**DIVISION OF RATEPAYER ADVOCATES
CALIFORNIA PUBLIC UTILITIES COMMISSION**

**Report on the
Pipeline Safety Enhancement Plan of
Pacific Gas and Electric Company**

Pipeline Modernization Plan

January 31, 2012

1 Figure 13 – Results of PG&E QRA analysis for entire PSEP

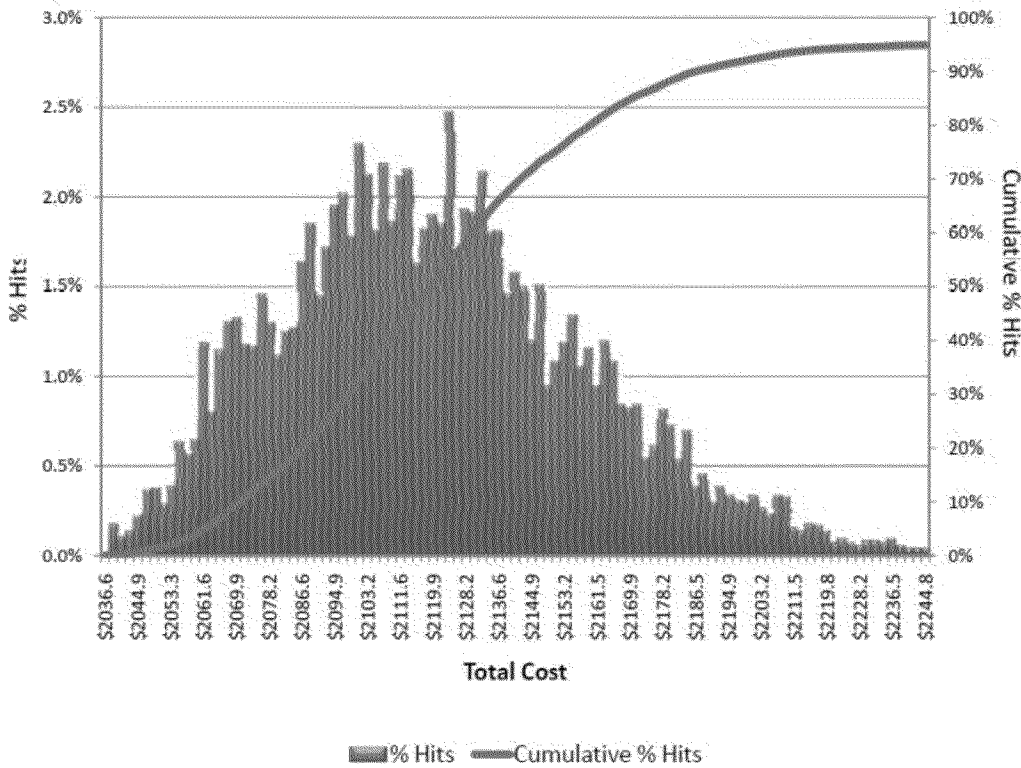
PG&E’s QRA analysis is best summarized by the “Cumulative % Hits”
versus “Total Cost” relationship shown on Figure 7-5 of PG&E’s Testimony:¹⁸⁸

¹⁸⁸ Figure 7-5 in PG&E’s Testimony is incorrect. See PG&E’s response to DRA data request DRA_041-07. A corrected figure was provided in the January 20, 2012 Errata filing, p. 7-42.

1 Figure 7-5 would show that there would be a probability of greater than zero (P0)
2 that actual costs will be less than the 2,036.6 million PG&E shows in Figure 7-5.
3 If PG&E were to use the ACEI Classification Range (-30% to +50%) shown in
4 Table 7-6 for Class 4 estimate, it can be argued that the P0 values should be even
5 *less* than the baseline cost of \$1,803.4 million. Given that DRA's analysis shows
6 PG&E's baseline cost estimate to be higher than industry averages, the QRA
7 should show a significant probability that actual costs could be lower than the
8 baseline estimate. The histogram shown in Figure 7.5 does not show distribution
9 of outcomes for actual costs on either side of the base estimate as the ACEI
10 range for a Class 4 estimate would indicate. At a minimum, the QRA should show
11 a significant probability that actual costs could be less than PG&E's current
12 2,036.6 million estimate at P0. It appears as if PG&E tailored its assumptions for

13 the QRA model to obtain a pre-determined level of contingency for the PSEP
14 Pipeline Plan project, rather than using reasonable assumptions to let the QRA
15 model suggest a proper level of contingency.

1 Figure 15 – PSEP Contingency request for pipeline replacement compared to
 2 PG&E QRA results¹⁹¹

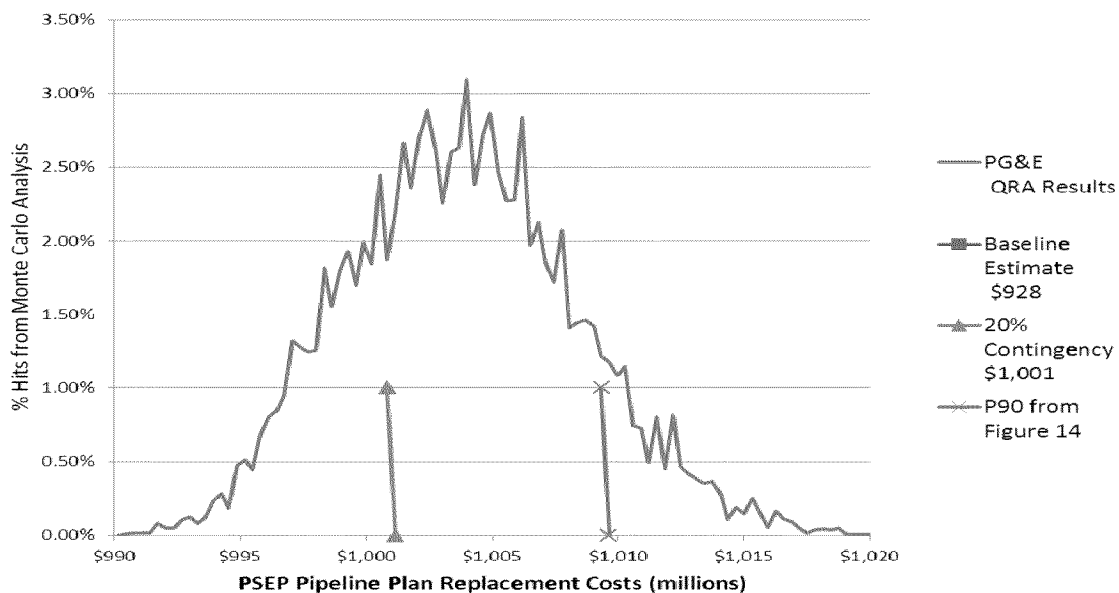
Figure 15 illustrates that PG&E’s QRA provides outcomes roughly centered on the 20% value chosen by PG&E, but skewed to the right (greater probability of higher cost). This figure also illustrates the discrepancy mentioned in footnote XXX of this exhibit, since PG&E’s 20% contingency is supposed to be a P90 value. It is clear from this figure that the 20% contingency is not a P90 value.
